**LATHROP DITCH IMPROVEMENTS
ITB-25-05****ADDENDUM NO. 4****March 11, 2025****Invitation for Bid No.: ITB-25-05**
Bid Opening Date and Time: 2:30 P.M., March 18, 2025

The following changes, clarifications, and or additions are hereby made to the City of Fairbanks LATHROP DITCH IMPROVEMENTS, ITB-25-05.

A2

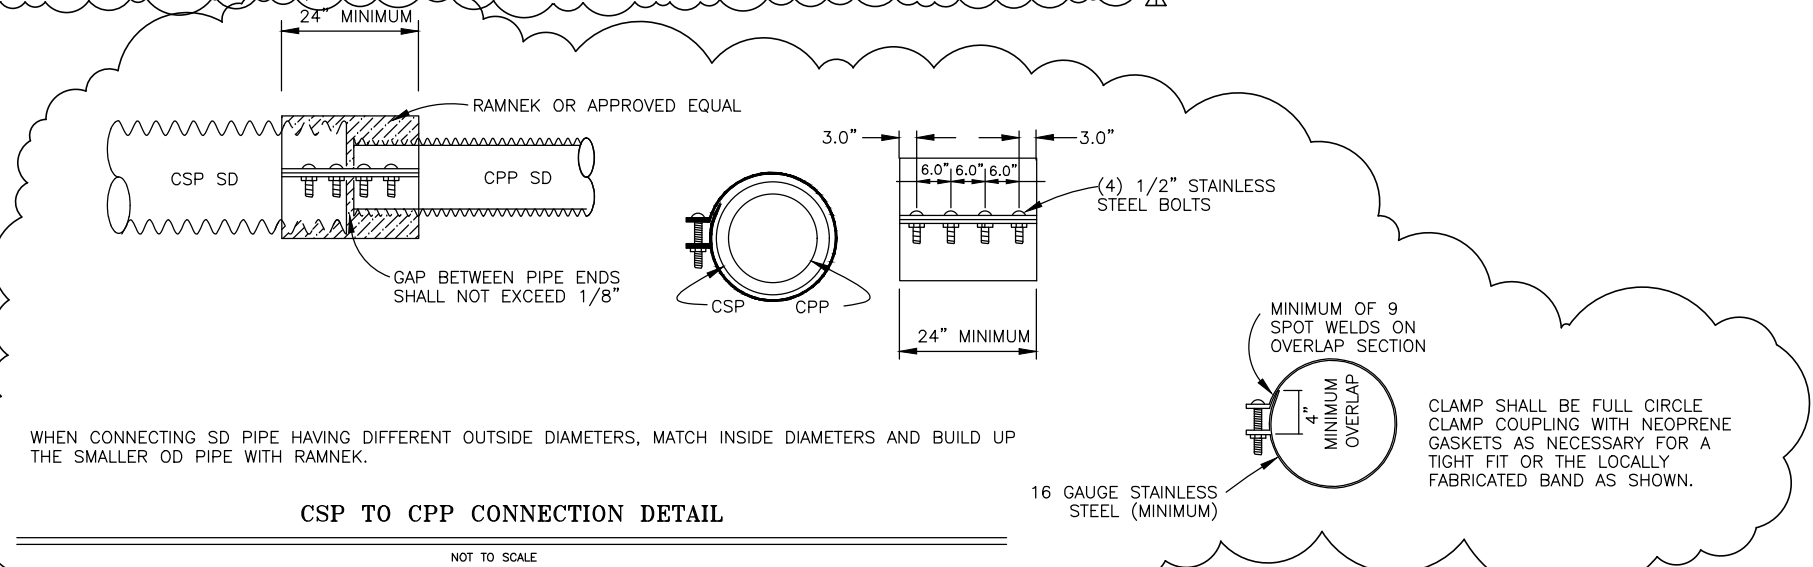
Delete Plan Sheet Nos. A2, U3, and U5 and substitute revised Plan Sheets Nos. A2, U3, and U5.
